**STAFF REPORT
DEVELOPMENT COMMISSION
ZONING MEETING
CITY OF COLUMBUS, OHIO
NOVEMBER 11, 2010**

- 4. APPLICATION:** **Z10-005 (ACCELA # 10335-00000-00074)**
Location: **6698 EAST BROAD STREET (43213)**, being 31± acres located at the northeast corner of East Broad Street and Brice Road. (010-165722)
Existing Zoning: M-2, Manufacturing District.
Request: CPD, Commercial Planned Development District.
Proposed Use: Building materials supply dealer and commercial uses.
Applicant(s): Menard Inc; a Wisconsin Corporation; 5101 Menard Drive; Eau Claire, WI 54703.
Property Owner(s): Columbus Corporate Center Inc; 191 West Nationwide Boulevard; Suite 200; Columbus, OH 43215
Planner: Dana Hitt, AICP, 645-2395, dahitt@columbus.gov

April 20, 2010

1. **APPLICATION:** **Z10-005 (ACCELA # 10335-00000-00074)**
Location: **6698 EAST BROAD STREET (43213)**, being 31± acres located at the northeast corner of East Broad Street and Brice Road. (010-165722)
Existing Zoning: M-2, Manufacturing District.
Request: CPD, Commercial Planned Development District.
Proposed Use: Building materials supply dealer and commercial uses.
Applicant(s): Menard Inc; a Wisconsin Corporation; 5101 Menard Drive; Eau Clair

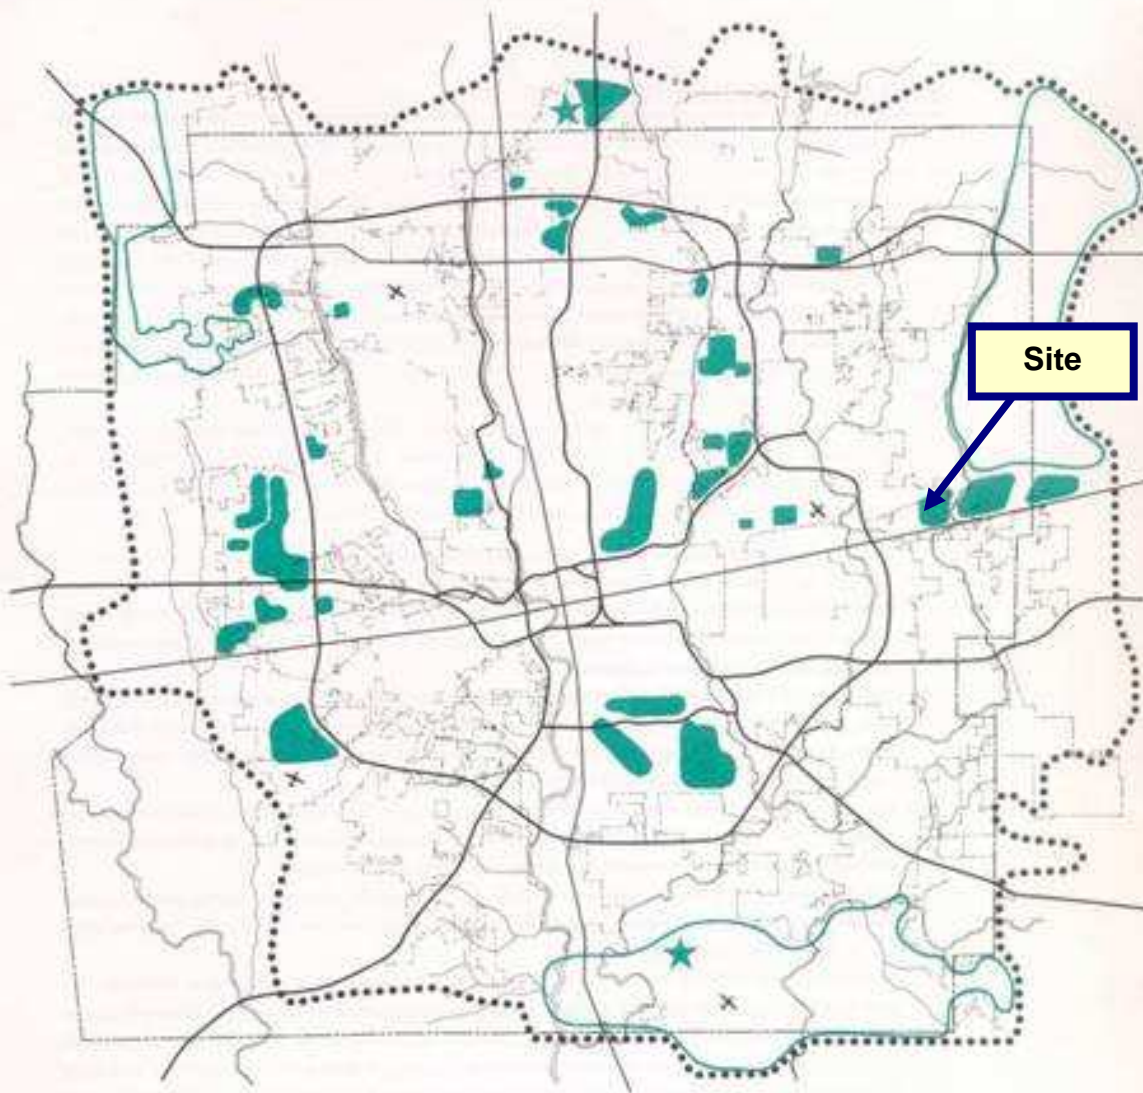
1. Staff sees no need for any use restrictions. Concerning Bars, Cabarets and Nightclubs, Staff cannot enforce a use restriction that would require Code Enforcement to inspect sales receipts. Please add a note to the CPD Plan stating all graphics shown are illustrative. A new parking and parking lot landscaping and lighting Code is about to be adopted by City Council. Staff suggests trying to comply with this new Code as much as possible. The new requirements may negate the need for some of the limitations that are requesting. You do not need to list the height district in the text nor do you need to state you'll comply with section 3385.09 as that goes without saying. Please provide an elevation of a treated lumber pallet racking structure. If you wish to file a Graphics Plan for this site, your CPD Text will need to be changed to indicate that. You may contact Dana Hitt at 614-645-2395 to discuss these matters.

2. Staff strongly recommends you contact commercial zoning clearance at 614-645-8637 to arrange to have a revised site plan reviewed.
3. Staff is concerned about the setback from the floodway and other flood way issues. Please contact Paul Freedman at 614-645-0704 to discuss these issues.

4. A traffic impact study is required. -The developer will be responsible for any signal modifications required for this development. -If access to Brice Rd. is proposed, the Brice Rd. connection will need to be built by the developer. -There will likely be a requirement to provide a 10' shared use path along the E. Broad St. frontage. -Please determine if Subarea I and Subarea II are to be connected for purposes of the traffic impact study. We would recommend connectivity between the two Subareas. -Right-of-way dedication of 80' from centerline along E. Broad St. is required per C.C.C. 3125.17. Please provide

justification for the requested parking variance.-Dan Blechschmidt is the contact (614-645-1694).

5. Call Maureen Lorenz with the Division of Recreation and Parks at 645-3306 regarding PDO requirements and stream issues.
6. This site is located within a half mile of COTA bus stops and a Post Office but the uses are not connected. Healthy Places features included in the site design are a pedestrian connection from the sidewalk on East Broad Street to the building in Subarea 1. Healthy Places recommends the following considerations to encourage an active living lifestyle: 1) Pedestrian connection from East Broad Street to the building in Subarea 2; and 2) Centrally located bike racks for residents, employees or visitors that ride their bike by choice or because of limited alternatives. You may contact Christine Green to discuss these suggestions at 614-645-5318.
